Addendum

Project Management Plan

Run IIb D-Zero Detector Project

V6.0
November 25, 2003

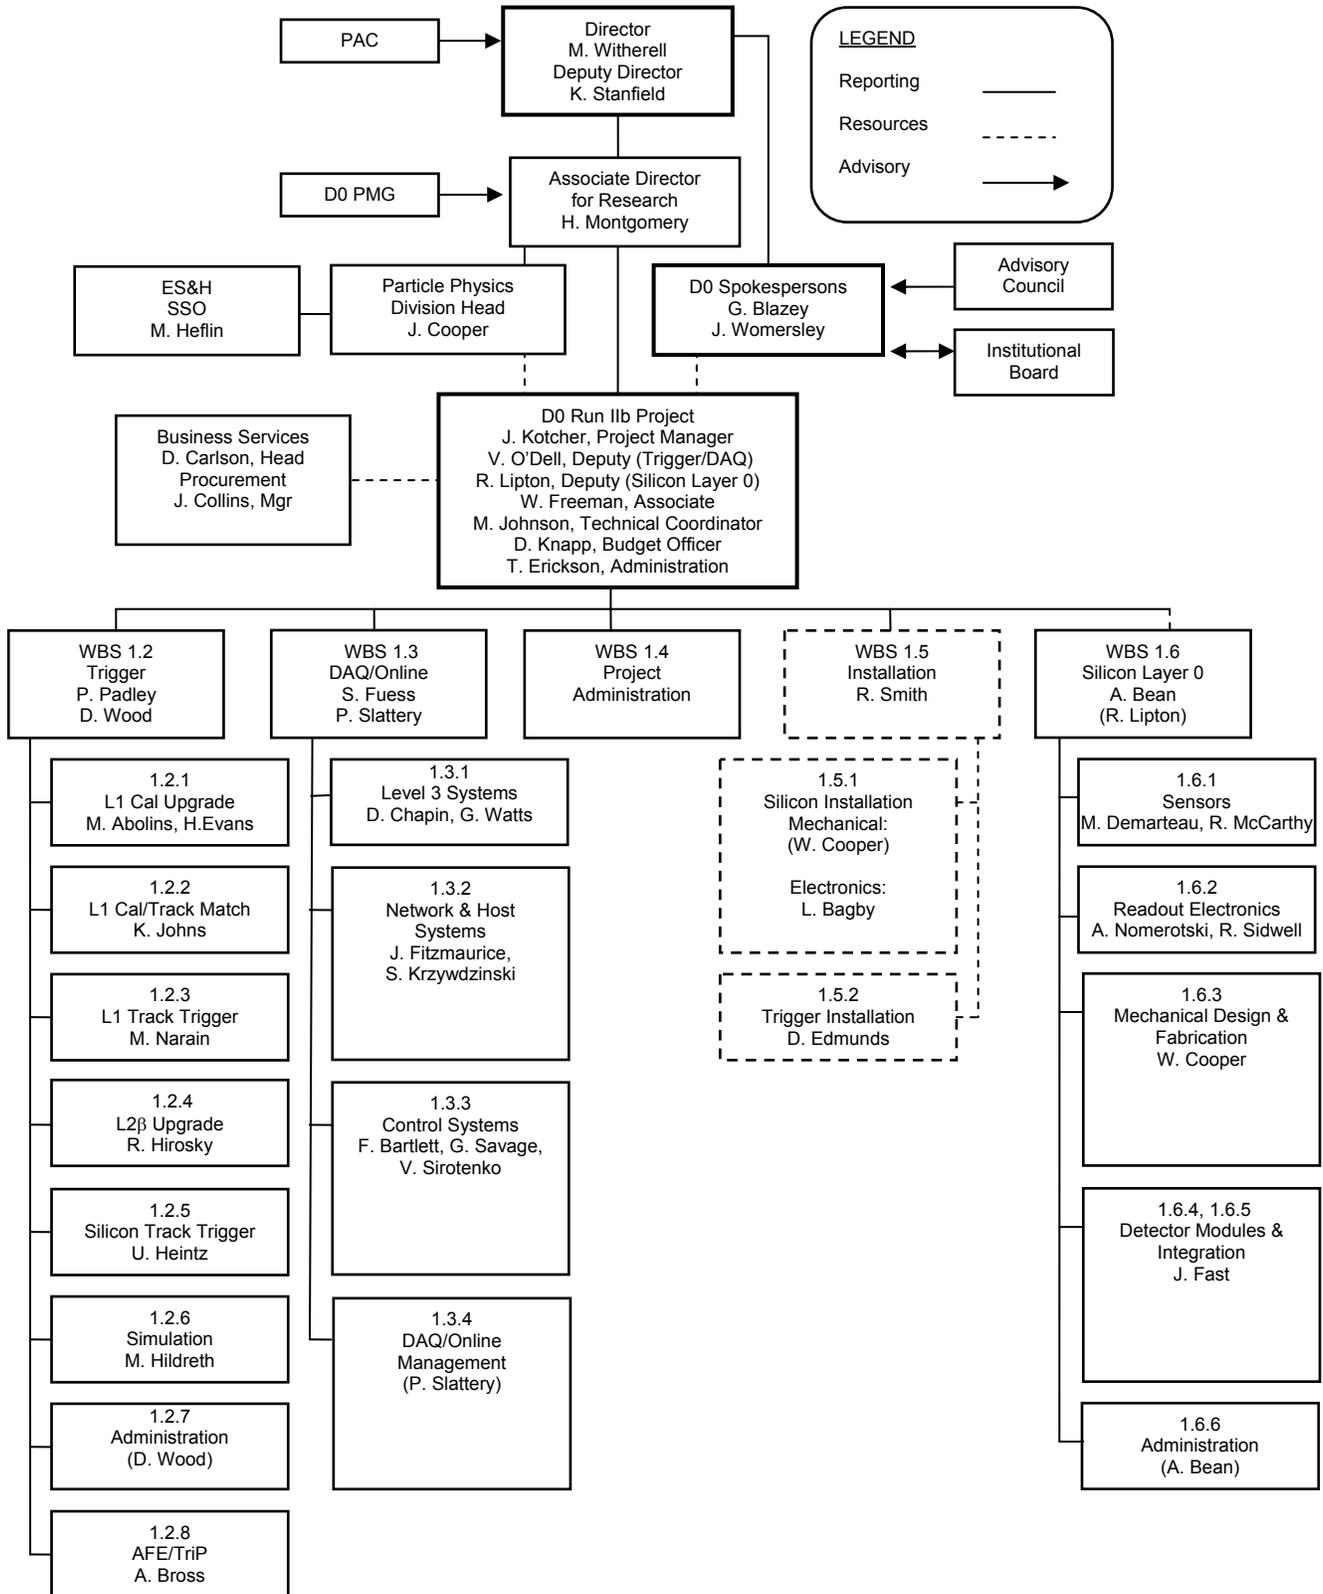
Figure 1 should be replaced with the following modified organizational chart. Note that WBS 1.1 is not included in this revised chart since it only includes closeout items associated with the original scope of the silicon detector.
